<b>ATTENTION</b>	Expert Consenting Panel - Ashbourne
<b>SUBJECT</b>	Response to Minute 14 (Points 3, 4, 5 and 6)
<b>AUTHOR</b>	Clare Houlbrooke

This memorandum provides a response to Minute 14, the Ashbourne Development.

The panel have requested a response to queries on the mounding assessment for proposed Stormwater Basin A.

**Figure 2: Groundwater Levels at the Ashbourne Site**

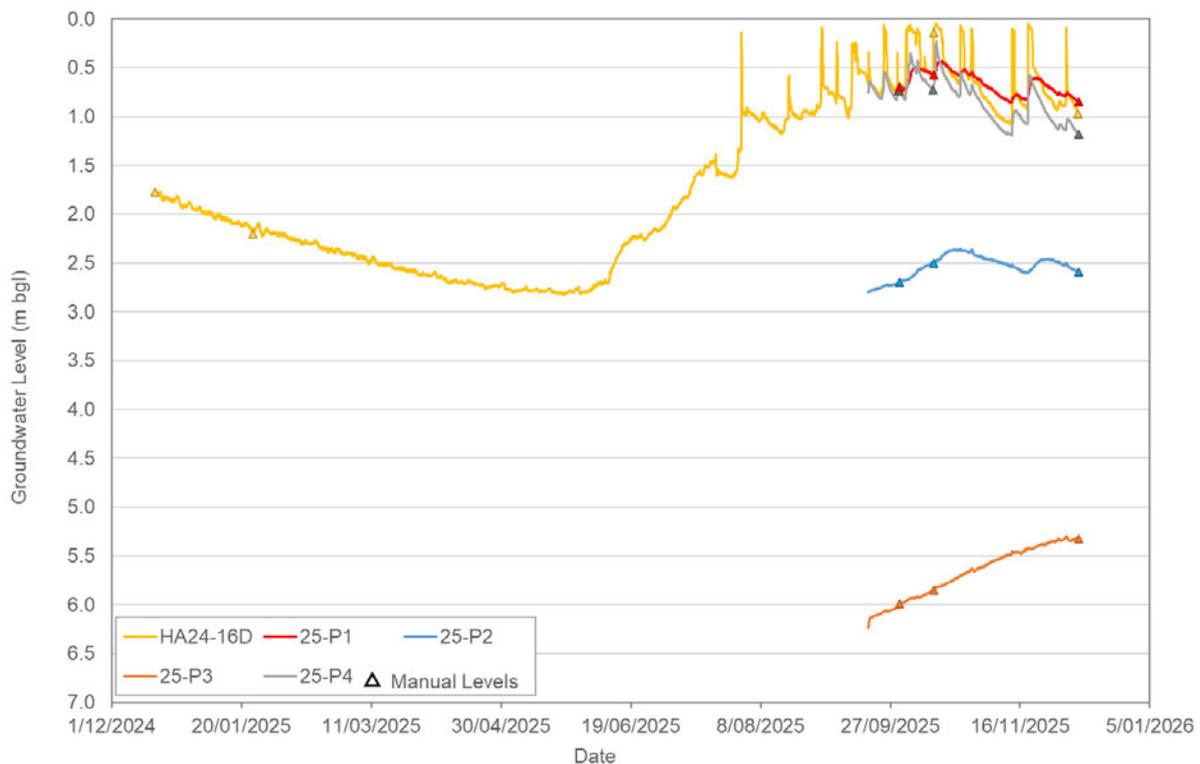
*In Figure 2 of the 29 January memorandum, the maximum mounding depth arising from a three day 100 year ARI rain event is shown as 6 m. The Panel's review of the available information on likely groundwater depth at the location indicates that the maximum mounding water level would be approximately RL 67.2 m, which is above the design 100 yr WL in the basin per drawing C440-2 and above the ground level adjacent to the basin. This gives the Panel significant concerns about the robustness of the stormwater assessment for disposal from Basin A and the ability to develop consent conditions that adequately deal with the uncertainties of future groundwater levels at the basin location, together with uncertainties inherent in the mounding assessment.*

The maximum allowable groundwater level rise is an input parameter for the model.

WGA notes that the October mounding modelling included a lower groundwater level (6.0 m below the top of basin) than used in the original assessment (3.5 m below the top of basin). Therefore, although the mounding increases due to increased “head room” under the basin, the depth to groundwater at nearby structures is greater due to the lower groundwater level starting point. WGA understands that it is the depth to groundwater level which is considered in the liquefaction assessment by CMW. Therefore, all updated results are effectively improved from the original modelling reported in June 2025.

In the modelling carried out October 2025, a groundwater level of 60.5 m RL was used to calculate the available mounding. This level was derived from measurements in piezometer 25-P3 in October 2025 of 6.1 m below ground level (bgl). The ground level at the piezometer 25-P3 is 66.6 m RL based on 1 m lidar elevation data. Therefore, based on a groundwater level of 6.1 bgl the groundwater level is 60.5 m RL. The top of basin is at an elevation of 66.5 m RL. Therefore, the maximum allowable mounding was set to **6.0 m**.

In the initial mounding modelling detailed in the WGA June 2025 report, the maximum allowable mounding was based on a groundwater level of **3.5 m** below top of basin. The additional modelling in October 2025 was carried out to check the potential increased infiltration from Basin A based on lower groundwater levels than the conservative original assessment.

Additional groundwater monitoring conducted since October 2025 has indicated water levels at piezometer 25-P3 have risen to 5.3 m bgl (61.3 m RL) in December 2025 and appear to be plateauing at this higher level (Figure 2).

**Figure 4: Underlying Hydrogeological Structures with the Position of Stormwater Basin A and Basin B (Blue Arrows)**

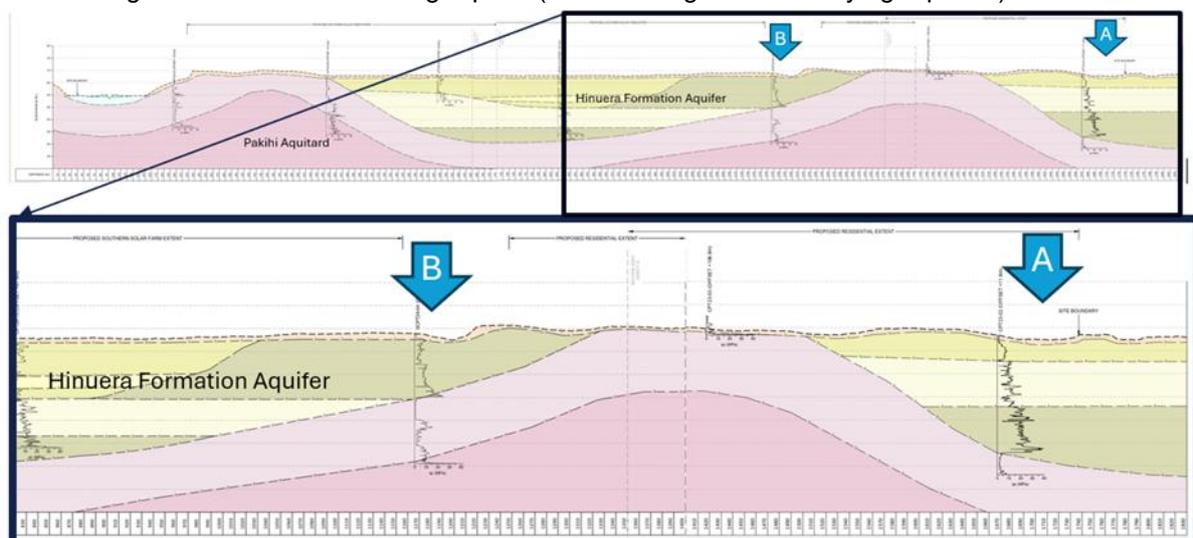
*In addition, the Panel understands that the runoff to Basin A in a three day 100 year storm used for the mounding assessment excludes the disposal of stormwater by soakage devices other than Basin A. Please comment on how the infiltration of stormwater to ground from this mechanism might affect the mounding assessment for Basin A.*

In terms of the stormwater soakage by other devices at the site, the other devices referred to in the question are generally located within the footprint of the hydrogeological basin underlying the western half of the site, where Basin B is shown in Figure 4. The groundwater levels in this area are represented by the data from Piezometer 25-P1 (Figure 2). In contrast, the groundwater levels within the footprint of the hydrogeological basin underlying the eastern section of the site, where Basin A is situated (Figure 4), are much deeper. The groundwater levels in this area are represented by the data from Piezometer 25-P3 (Figure 2). The groundwater levels recorded from Piezometer 25-P3 and rise slowly in response to recharge compared to the shallow groundwater in the area to the west.

The depth to groundwater under the eastern section of the Site is also evidenced through:

1. Our observations of a deep stormwater device on Peakdale Drive that had no observed groundwater inflow seepage during spring.
2. An absence of drainage systems on farmland in this area.

Some stormwater soakage is planned in the area to the east of the low permeability outcrop. However, WGA understands this will not be greater than the current recharge to this area.

Figure 5: Time series of Mounding at Basin A and Nearby Structures Following 36 day Winter Season (October 2025 Groundwater Levels)

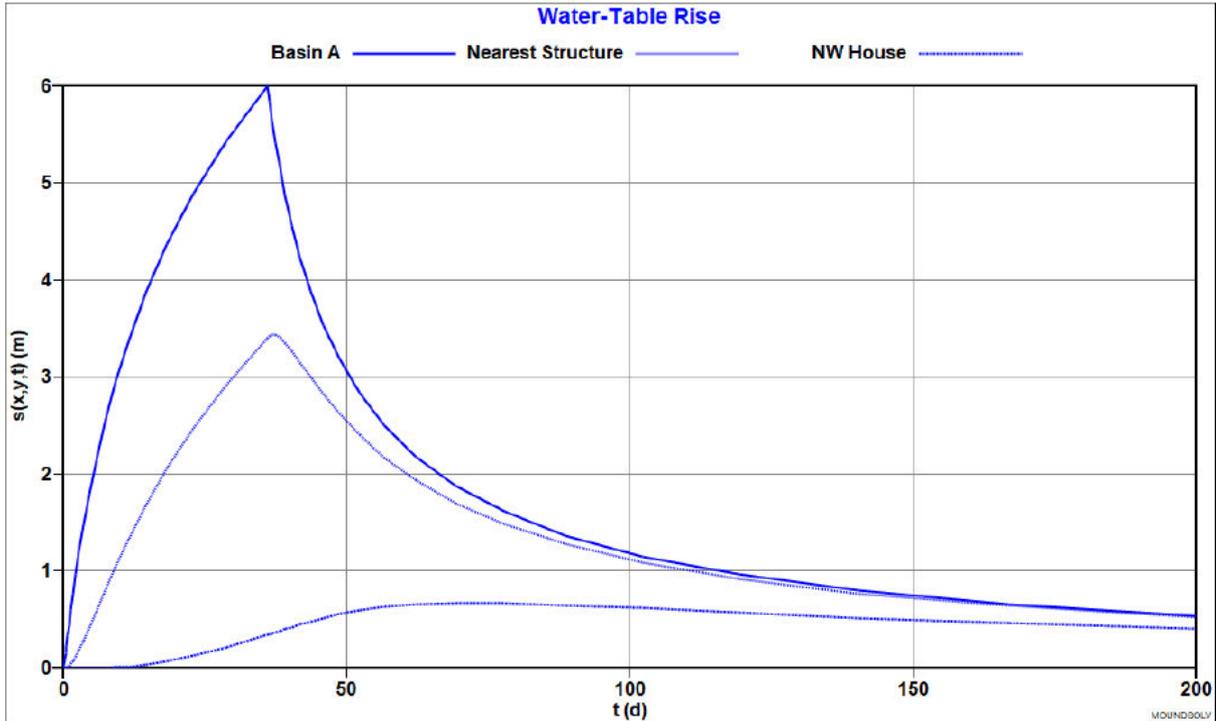
The Panel considers it to be imperative that a mounding assessment for Basin A include a winter season scenario as modelled previously and reported in the Hydrogeological Effects Assessment of June 2025.

This modelling has been carried out for the winter season based on 36 days for both the October 2025 water levels and the higher December water levels measured at 25-P3.

The winter scenario based on the October groundwater starting levels is included below to address the question from the panel. In addition, a corresponding mounding assessment based on December starting groundwater levels is included in Table 5 and Table 3.
